STAFF REPORT

PCA/CDPA 2011-PR-023/FDP 2011-PR-023-4

PROPOSAL: Replace a previously approved hotel with residential use on Block D.

ARBOR ROW - BLOCK D PROFFER CONDITION AMENDMENT & CONCEPTUAL DEVELOPMENT PLAN AMENDMENT

SHEET **C10.03**

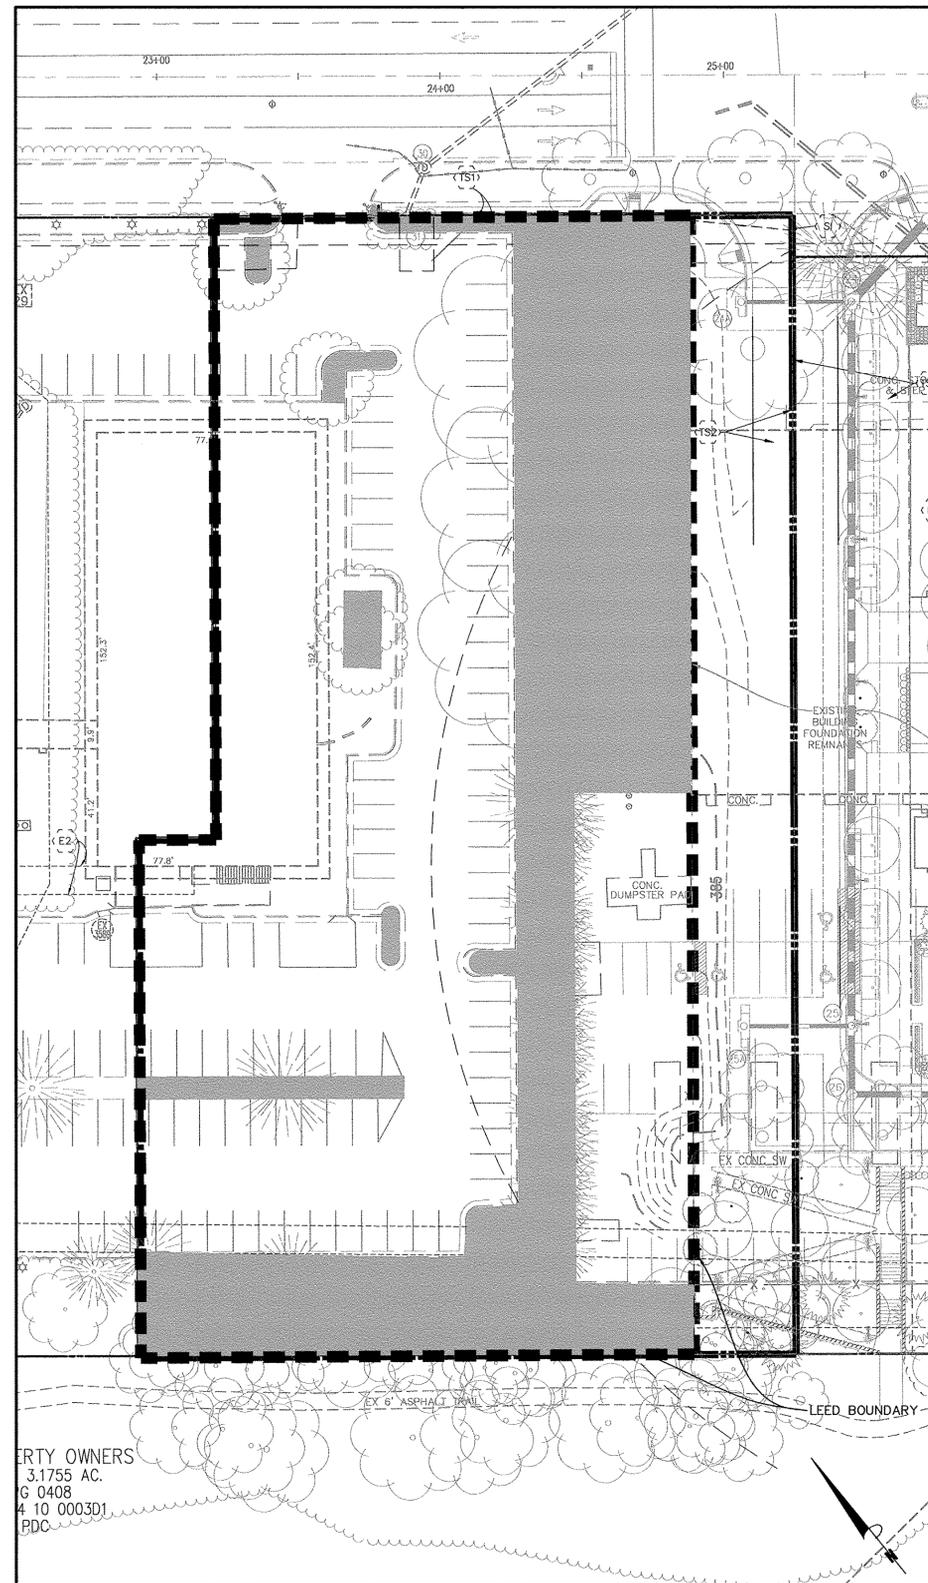
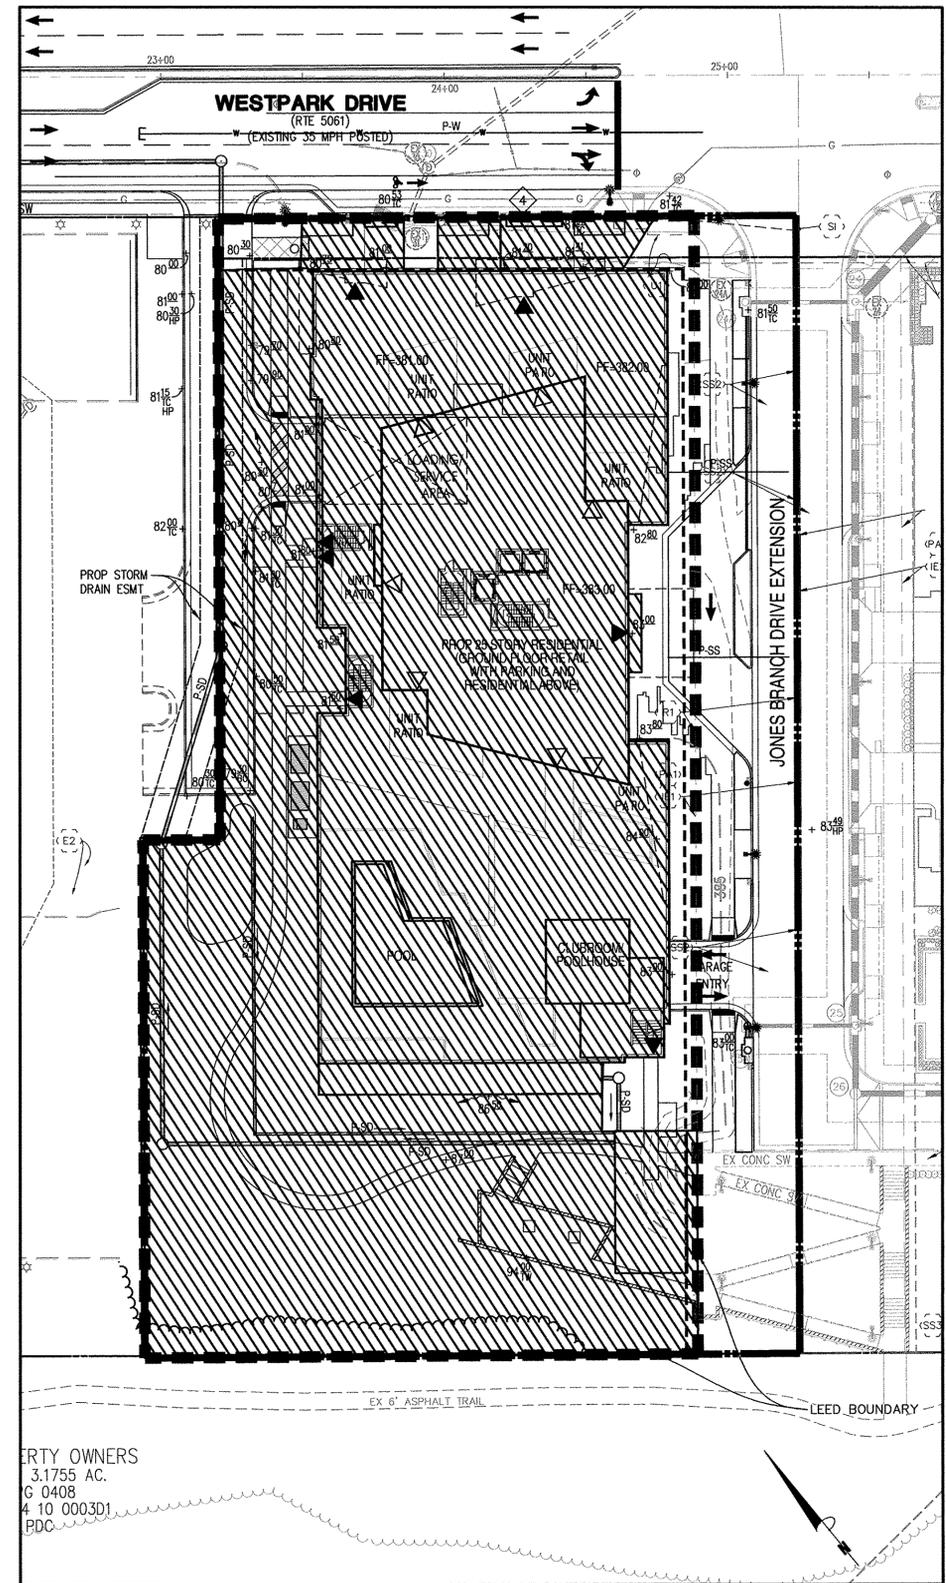
4. PCA/CDPA Sheet C-10.03. FDP Sheet C-9.6. LEED SS6.1 should verify volume reduction in cubic foot.
5. PCA/CDPA Sheet C-10.04. FDP Sheet C-9.1.
 - (1) Provide rainwater harvesting demand and supply analysis to support the efficiency claimed.

PLAN STATUS	
07.30.15	COUNTY COMMENTS
10.05.15	COUNTY COMMENTS
12.16.15	County Comm
12.30.15	Rev.
DATE	DESCRIPTION
SCALE:	AS NOTED
DATE :	MARCH 30, 2015
SHEET	L2.03

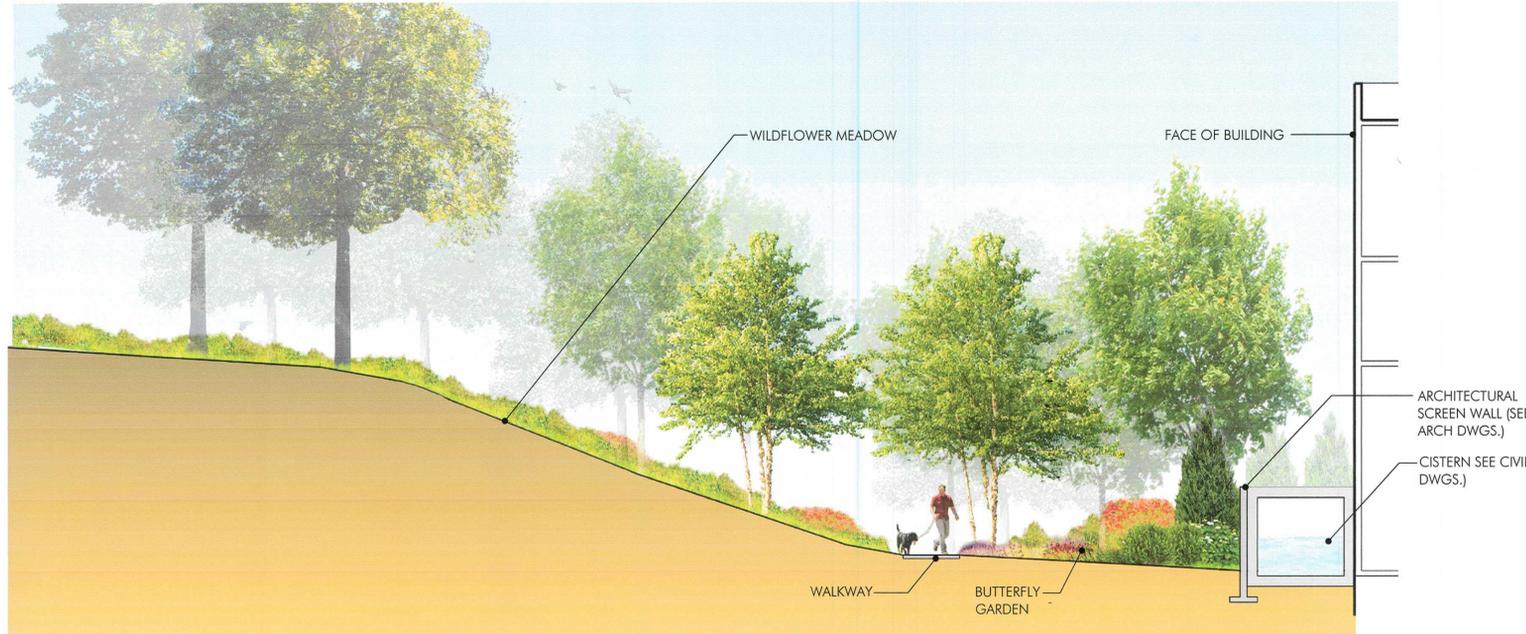
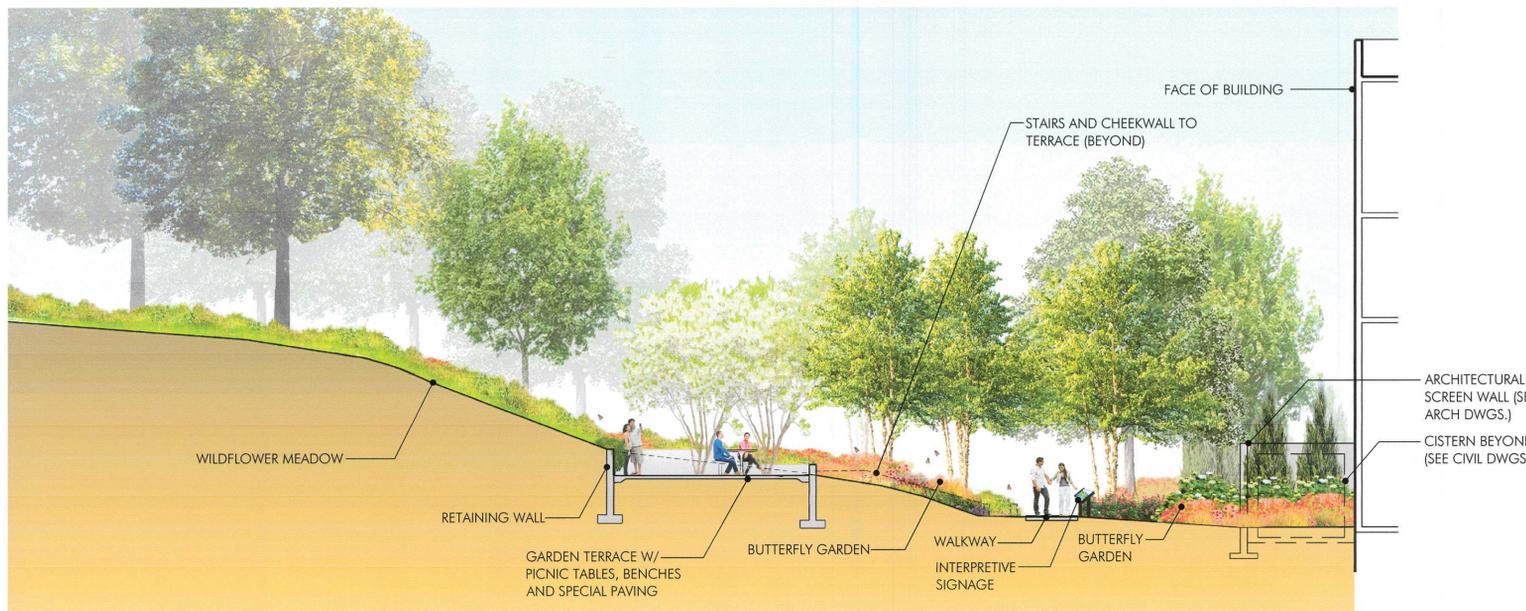
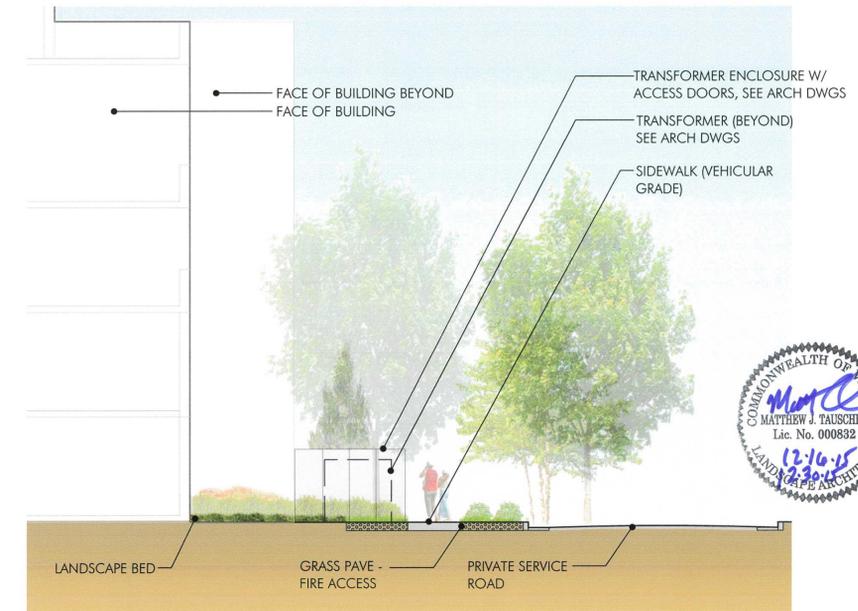
A large cistern is shown across the southern side of the building and visible in the cross sections on Sheet L2.03 of the FDP. Additional detail was requested regarding this structure. What materials/surfacing will be used? Is this an enclosed structure or open on the top? What is the proposed height of this feature? A note was added to the plan that the cistern would be enclosed by a masonry wall. A masonry wall can mean lots of things and does not convey the character of the enclosure and, ultimately, its visual impact on the publicly accessible park space. The Park Authority continues to request additional information regarding the cistern.

Figure 7 Ultimate Corner Park Condition (Source: FDP)

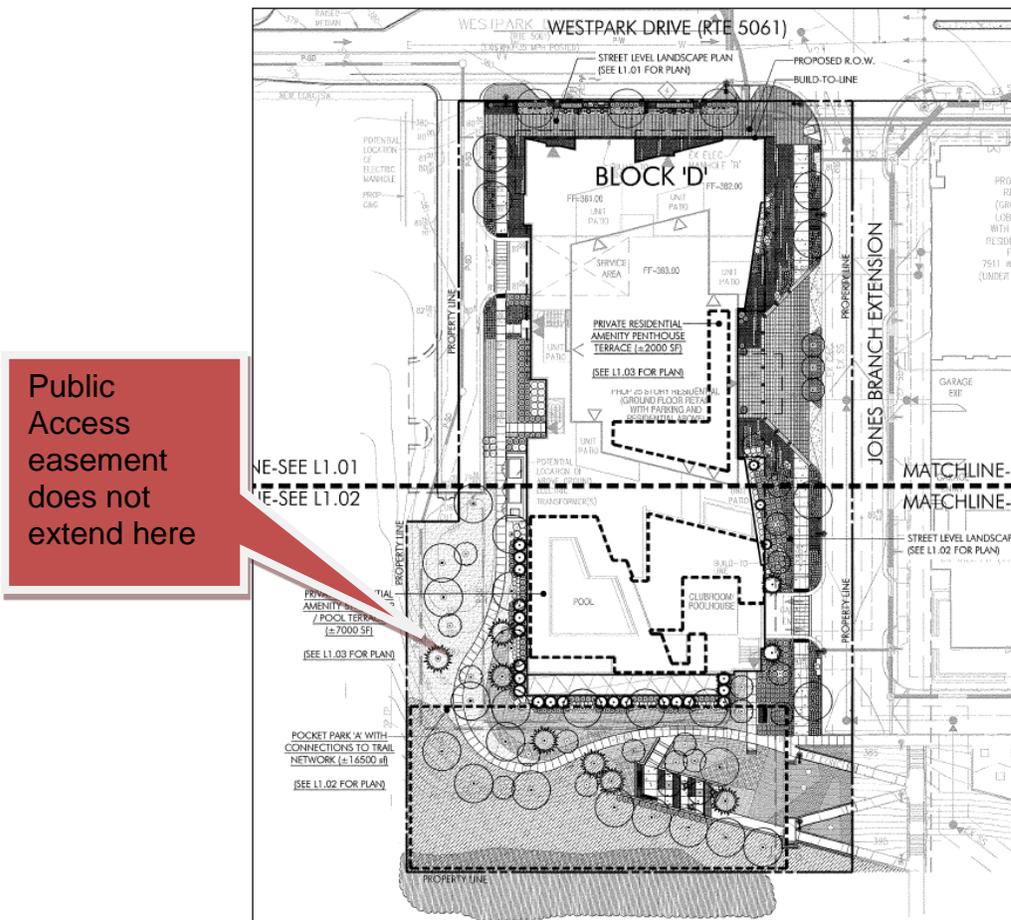
Staff notes that the park is not fully covered by a public access easement. Specifically, a large portion of the lawn to the west of the park will not be covered by an access easement. Since this area will look very much like the area covered by the access easement, with few visual cues to alert users of that area that some of the elements are private in nature, staff believes that the general public will find it difficult to understand where the public spaces end and the private spaces begin. Staff had advised the applicant to extend the access easement, but the applicant has declined to do so.
